Access Compliance Report

Public Rights-of-Way

Intersection ID: 28511	Main Street: BRAY_DR	Cross Street: HOLLY_PARK_DR	Location: N
ADA ID: B24AF3A99B35	Ramp Type: PerpDiag	Initial Pass/Fail: Fail	Overall Compliance: No
			Severity Score: 21.25

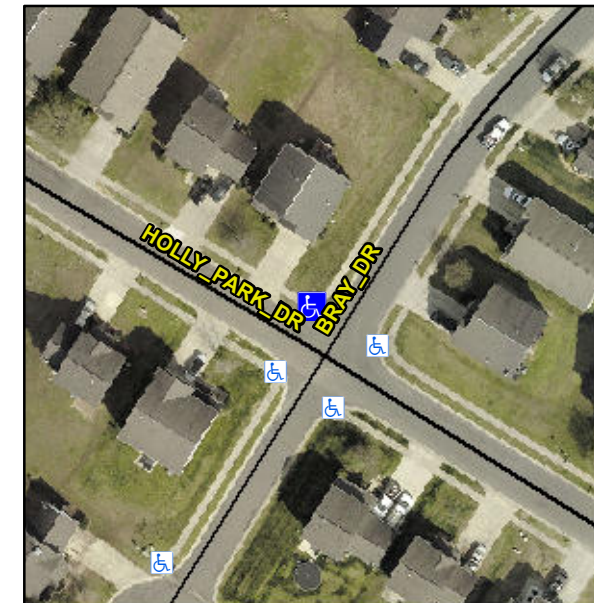
Not Found, R304.5.1, R304.5.3

Compliance	Description	Data	Compliance	Description	Data
N/A	Ramp Length (in)	47.0	Yes	Ramp Slope (%)	5.5
No	Ramp Width (in)	39.0	No	Ramp XSlope (%)	6.0
N/A	Flare Type LT	N/A	N/A	Flare Type RT	N/A
N/A	Flare Slope LT (%)	N/A	N/A	Flare Slope RT (%)	N/A
N/A	Flare Traversable LT?	N/A	N/A	Flare Traversable RT?	N/A
N/A	Landing Length (in)	N/A	N/A	DWS Provided?	N/A
N/A	Landing Width (in)	N/A	N/A	DWS Contrast?	N/A
N/A	Landing Slope (%)	N/A	N/A	DWS Length (in)	N/A
N/A	Landing X Slope (%)	N/A	N/A	DWS Full Width?	N/A
N/A	Landing Curb? (Y/N)	N/A	N/A	DWS Offset (in)	N/A
N/A	Shared Landing?	N/A			
N/A	Gutter Ponding?	N/A	N/A	Gutter Slope (%)	N/A
N/A	Gutter Lip Ht (in)	N/A	N/A	Gutter X Slope (%)	N/A
N/A	Painted X Walk1?	No	N/A	Painted X Walk2?	No
	X Walk 1 Direction	To SW		X Walk 2 Direction	To SE
N/A	X Walk 1 Width (in)	N/A	N/A	X Walk 2 Width (in)	N/A
	X Walk 1 Slope (%)	4.0		X Walk 2 Slope (%)	6.7
	X Walk 1 X Slope (%)	7.6		X Walk 2 X Slope (%)	0.3

Remove & Replace Curb Ramp With Two New Directional Ramps or Equivalent.
